# COBAR CONSOLIDATED RESOURCES LIMITED

## Response to DECCW Initiated "Stop the Clock" Issued on 24 January 2011

## WONAWINTA SILVER PROJECT

February 2011

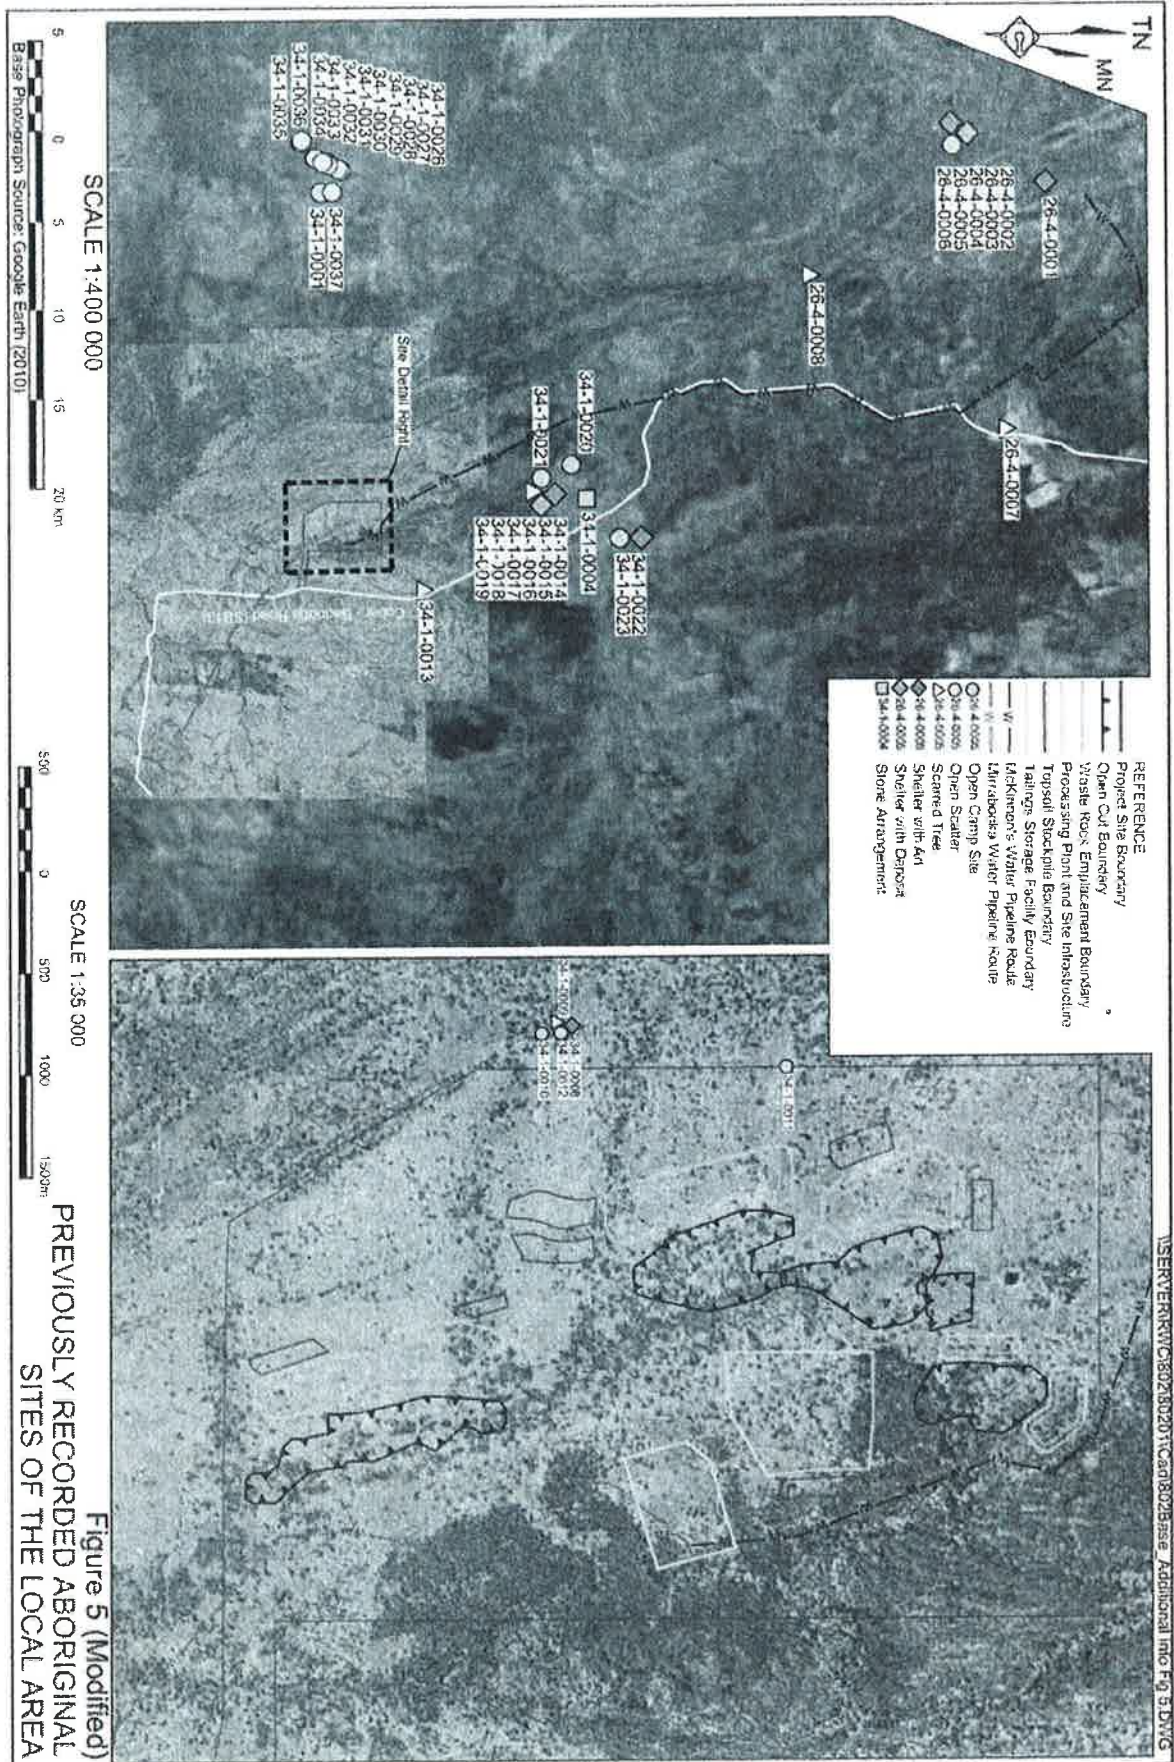
*The table associated with the map in Figure 5 is incorrect. In this table site 26-4-005 is identified as a Stone Arrangement. This is incorrect; it is an Artefact scatter.*

- 1. The map should be amended to accurately reflect this."***

The error is acknowledged and a corrected version of **Figure 5** (referenced as **Figure 5 – Modified**) is attached.

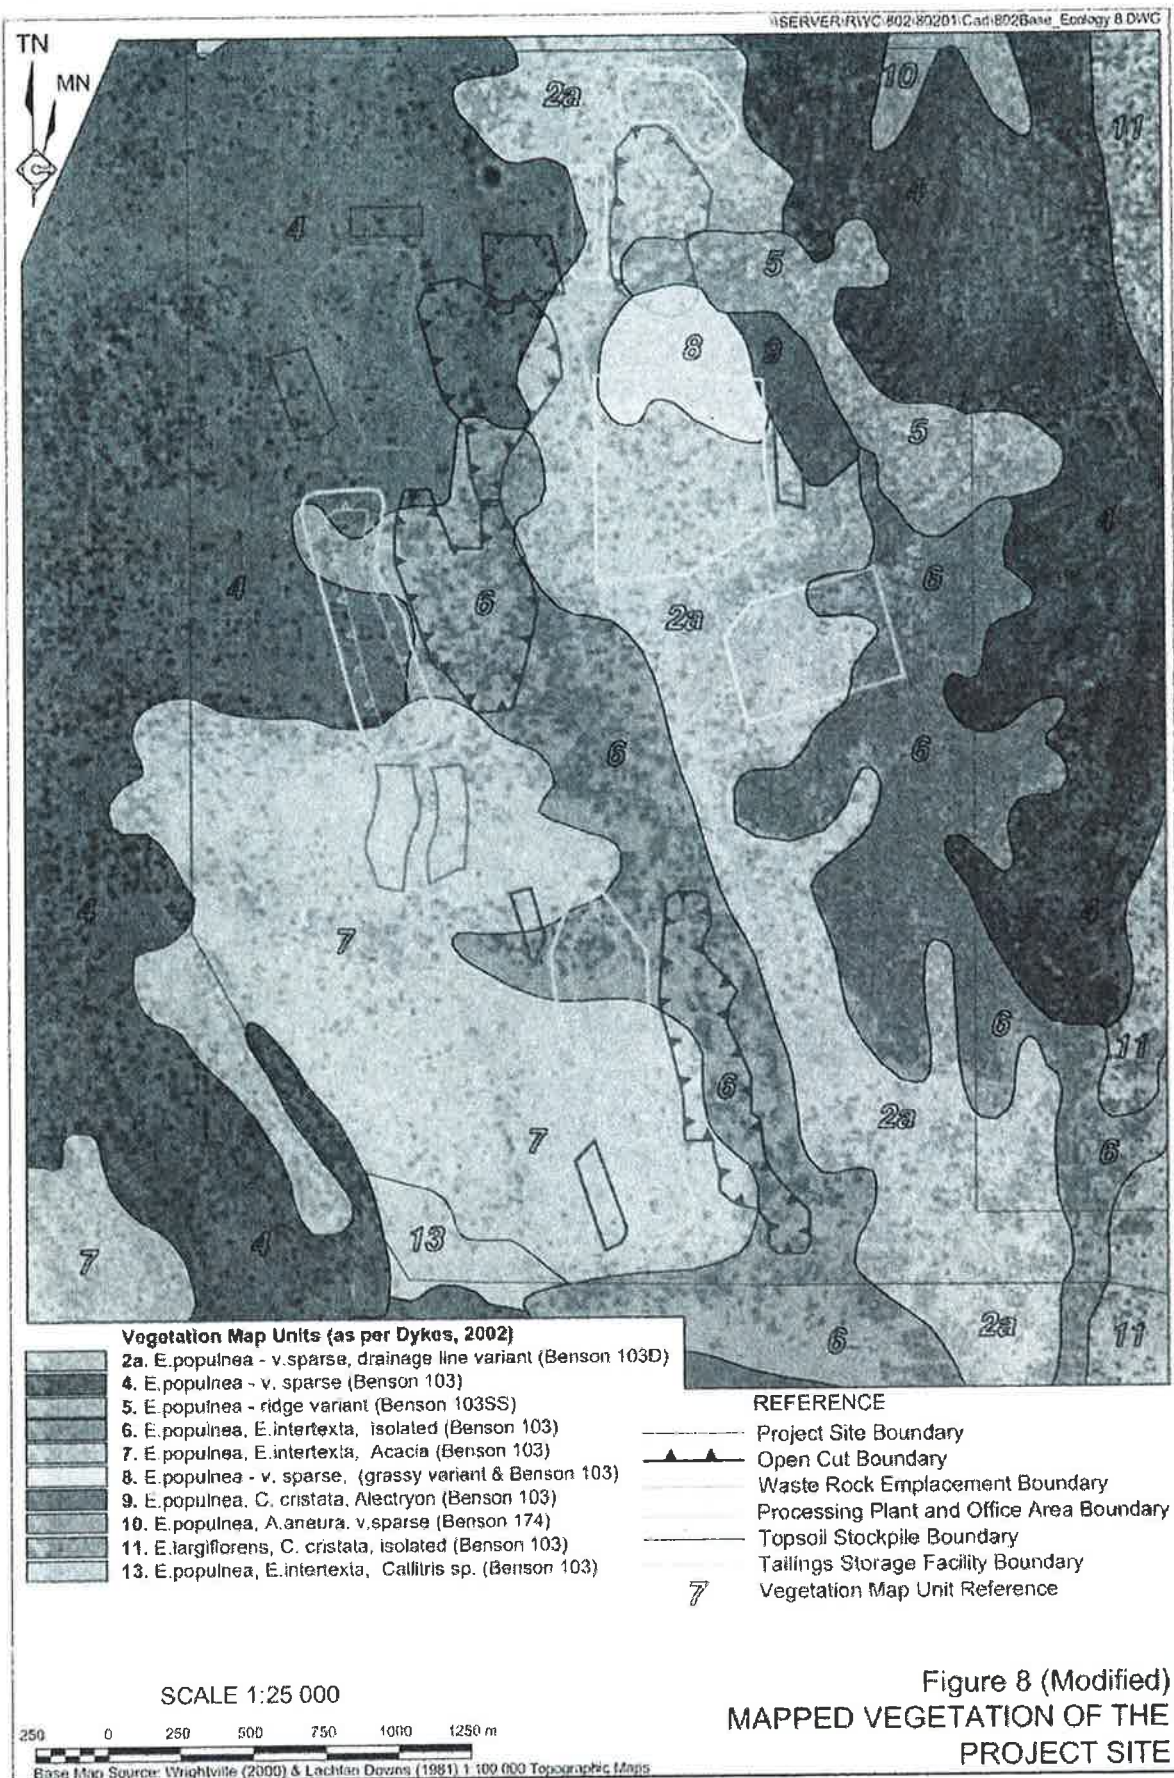
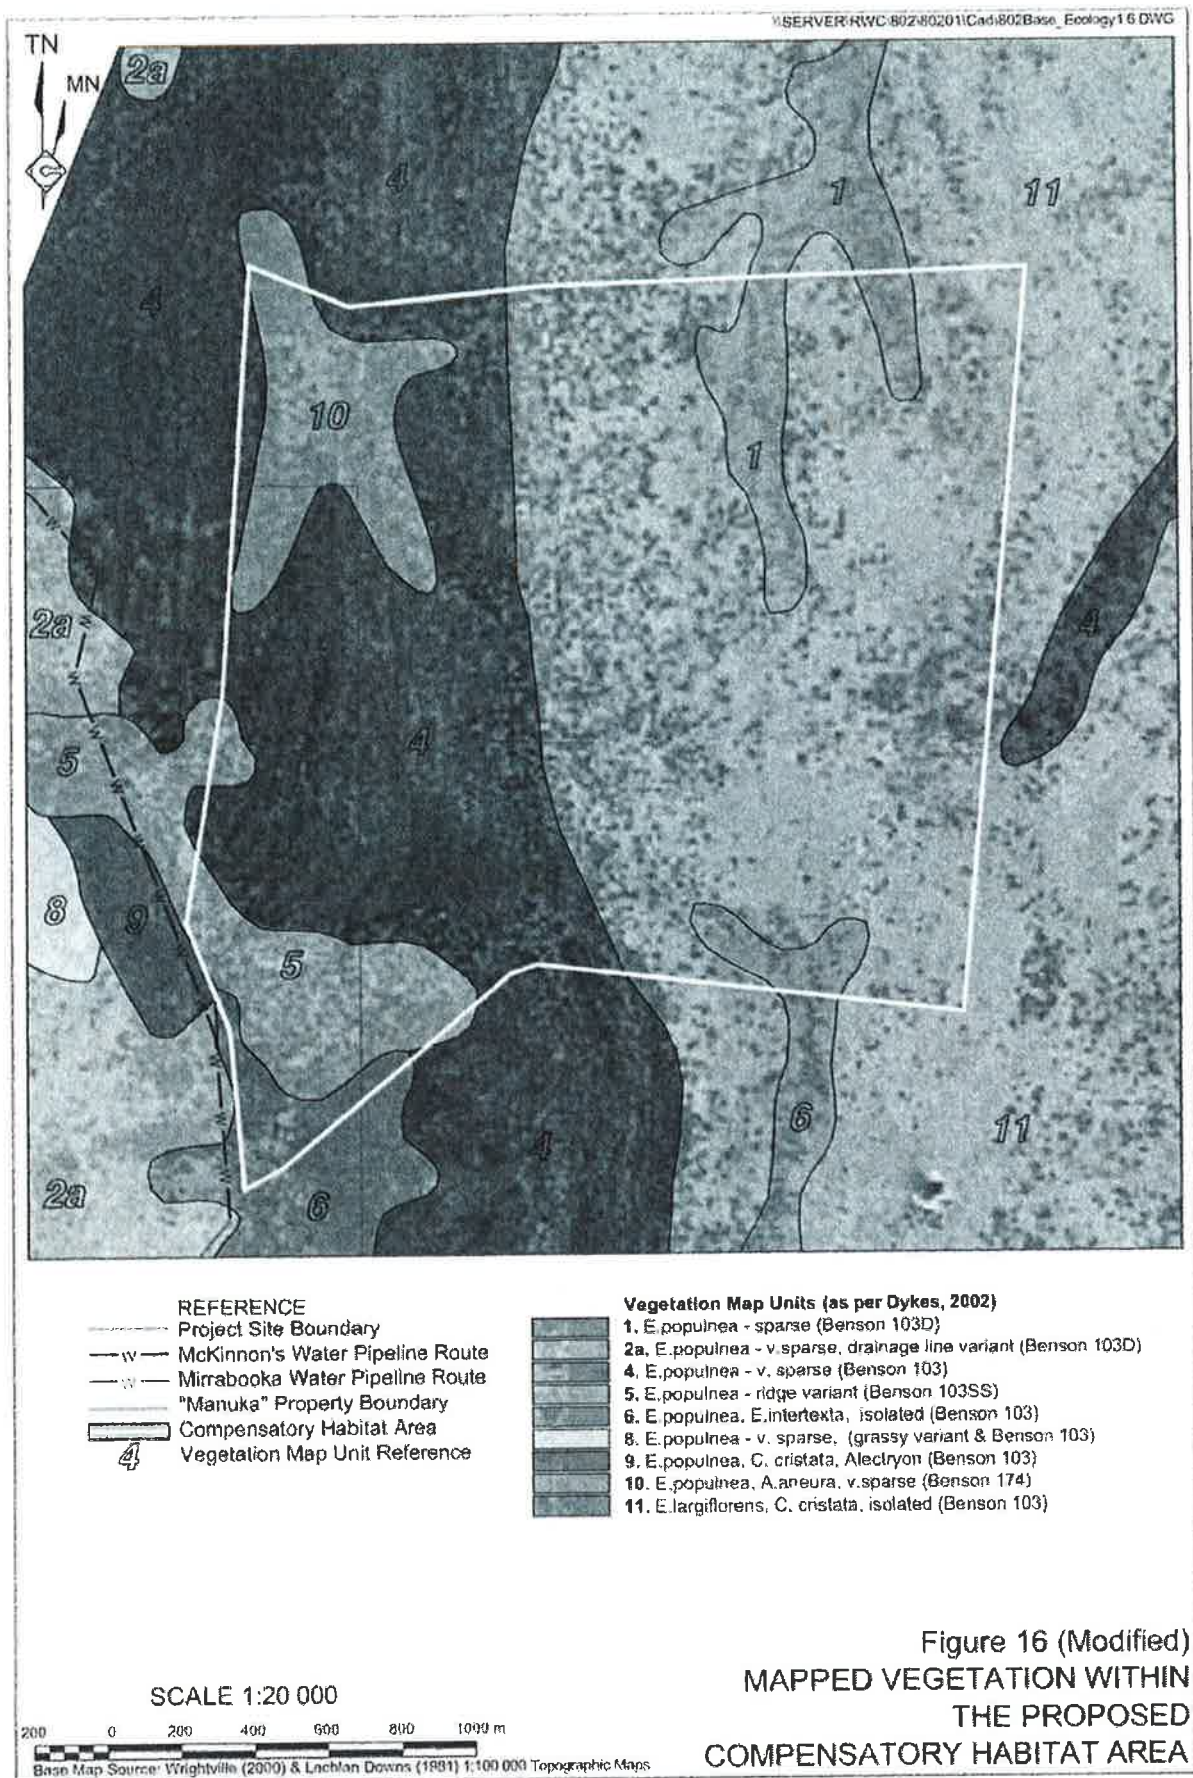
*Conflicting information is presented on impacts on vegetation communities and area of disturbance. ....*

*Furthermore, one vegetation community (coloured dark blue on the vegetation maps) is missing from the map legends throughout the EIS.*

*It is recommended that the proponent clarify and confirm the expected impacts on native vegetation communities."*

To assist in the assessment of impacts on vegetation, **Figures 6, 8 and 16** of the *Environmental Assessment* have been updated (renamed **Figures 6 - Modified, 8 - Modified and 16 - Modified**) to include the vegetation mapping unit (VMU) reference within the coloured polygons. Notably, vegetation mapping unit represented by the dark blue colour is **Vegetation Mapping Unit 4: *Eucalyptus populnea* – very sparse (Benson 103)**.

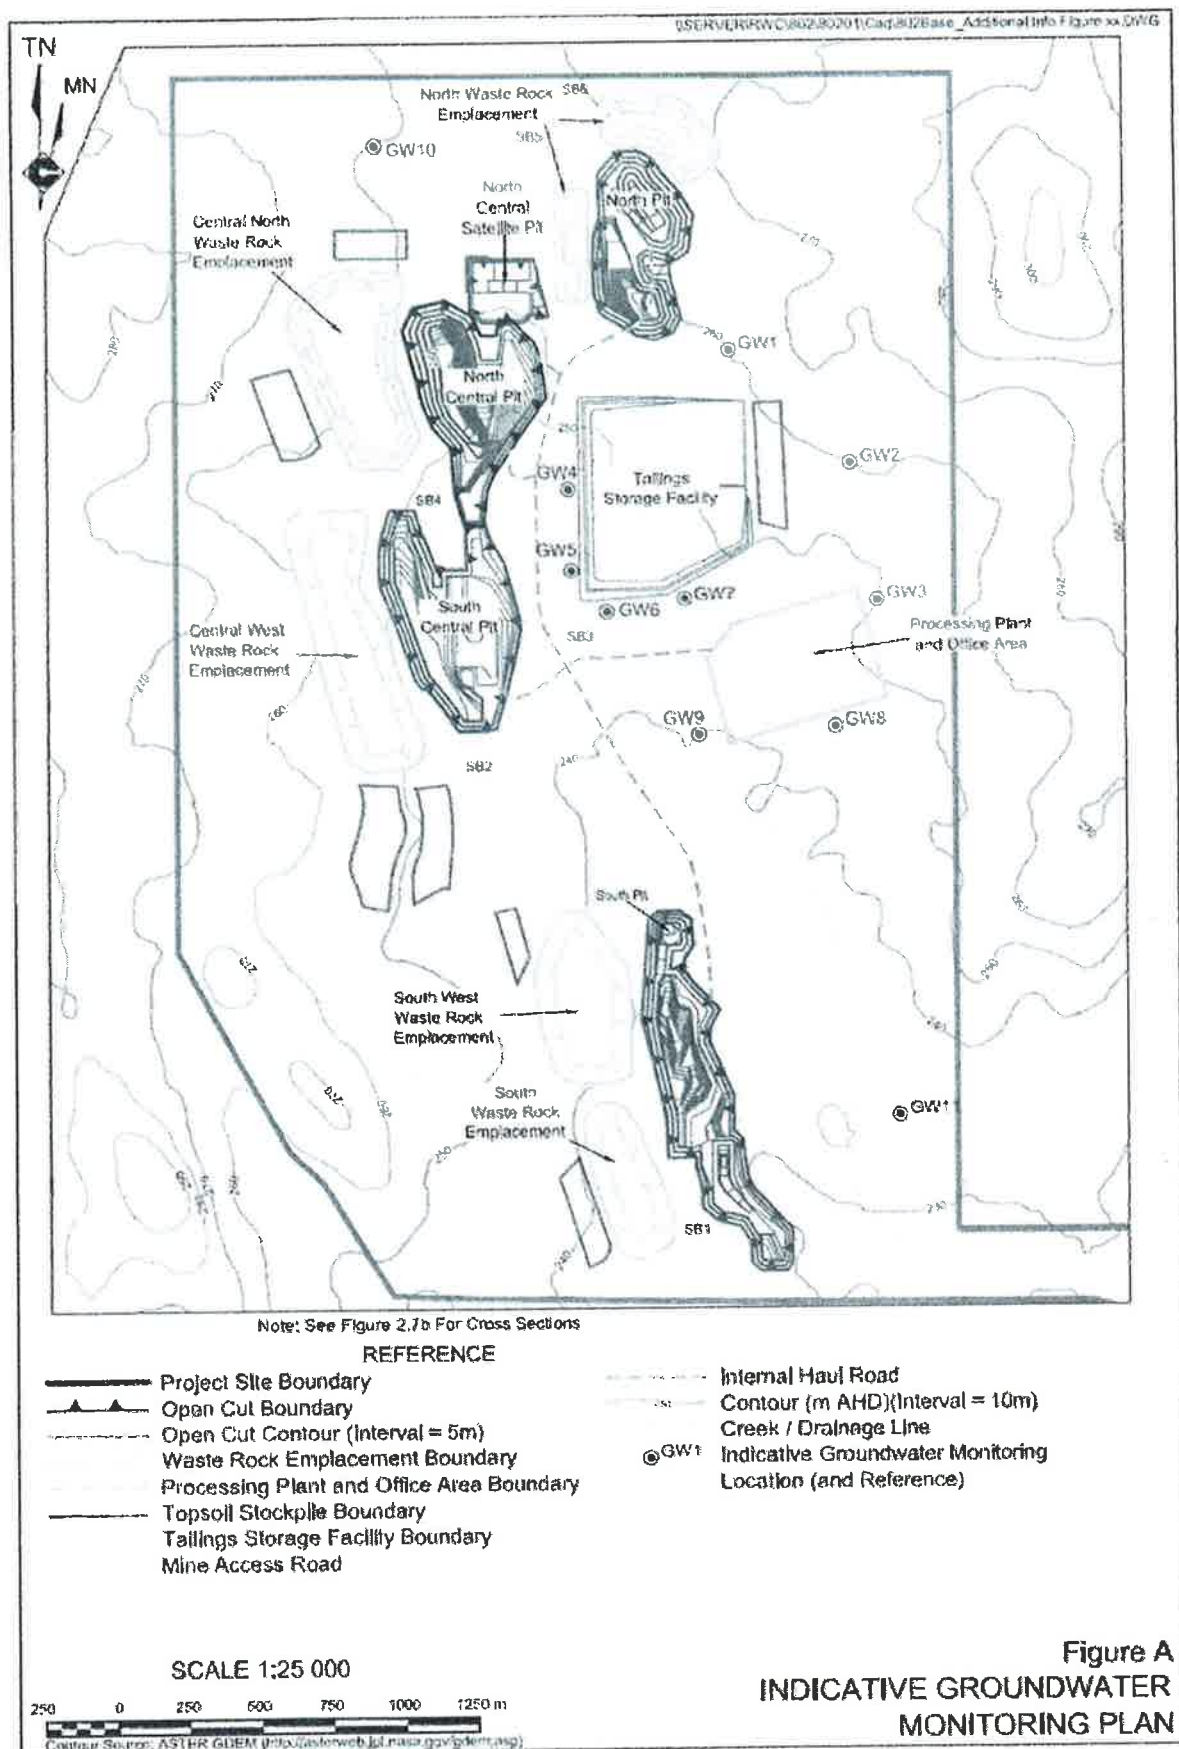
2. *Details of the proposed QA/QC program must also be provided to ensure earthworks (compaction etc.) are undertaken in the appropriate manner and the design criteria are achieved.*
3. *Further information is required regarding the proposed groundwater monitoring network particularly around the TSF, but also any other groundwater monitoring across the site. this includes the number and locations of piezometers, as well as parameters to be monitored*

3. The exact locations of groundwater monitoring bores would be identified following receipt of development consent and availability of final Tailings Storage Facility design. The Applicant would include these locations within an application for Environment Protection Licence to be submitted following receipt of development consent. Based on the final Project Site layout (see *Figure 2.1* of the EIS), and local topography (which is likely to influence sub-surface flows of water), **Figure A** provides the indicative locations of piezometers.

Piezometers placed up-gradient and down-gradient of the TSF and Processing Plant and Office Area, would likely be constructed as nested piezometers, targeting both near surface flows and the deeper aquifer. Piezometers placed beyond the pits would likely be constructed to access the underlying aquifer (measured to be between 190m and 200m AHD).

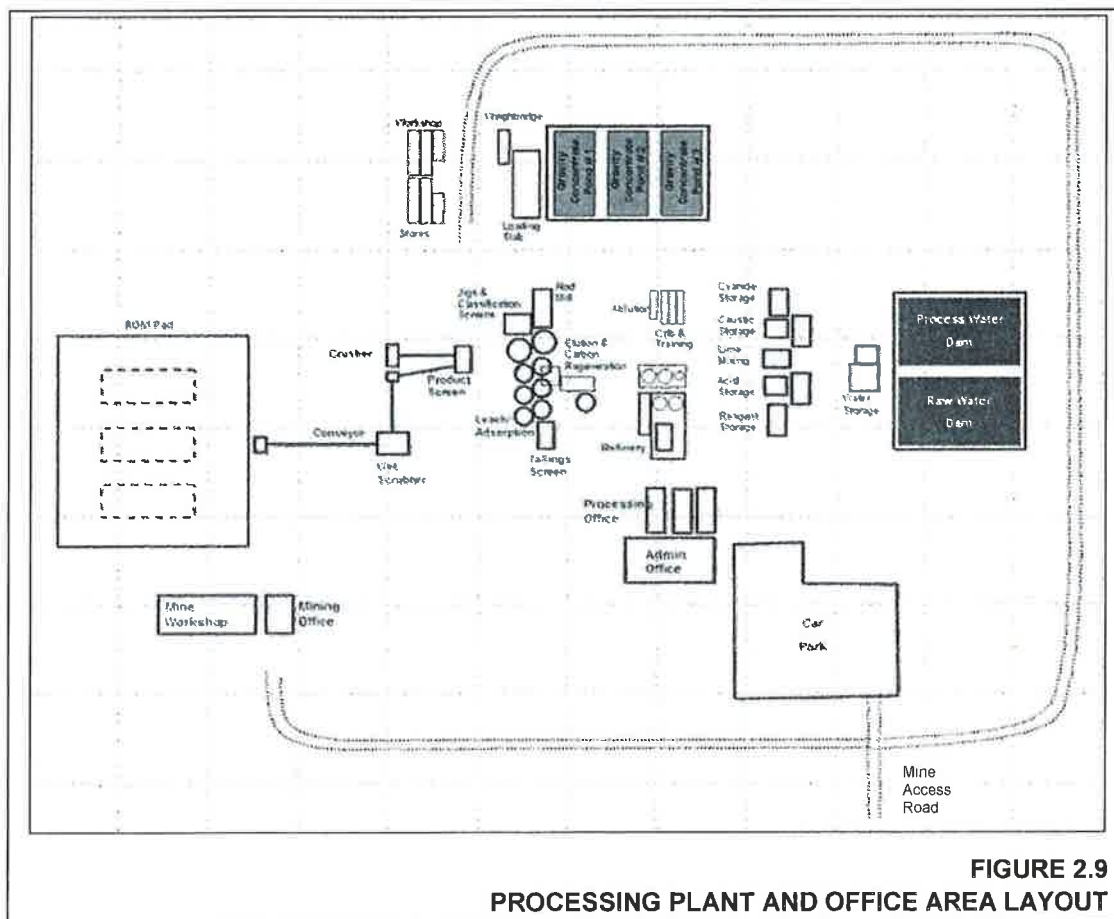
1. *The EIS does not make mention of the requirement for any contaminated water management structures onsite (only 'clean' and 'dirty'). Clarification is required as to whether any contaminated water storage structures are required as part of surface water management onsite and the location and design criteria for these structures.*
2. *The location, of the raw water dam is not provided on plans. This should be included on relevant plans."*

No contaminated water structures are required on the Project Site.

Runoff from equipment maintenance areas would be diverted to a sump (within the workshop area of the Processing Plant and Office Area) before being pumped through an oil-water separating unit.

The location of the Raw Water Dam is presented on *Figure 2.9* of the EIS. **Figure 2.9** is presented again below for DECCW's information.
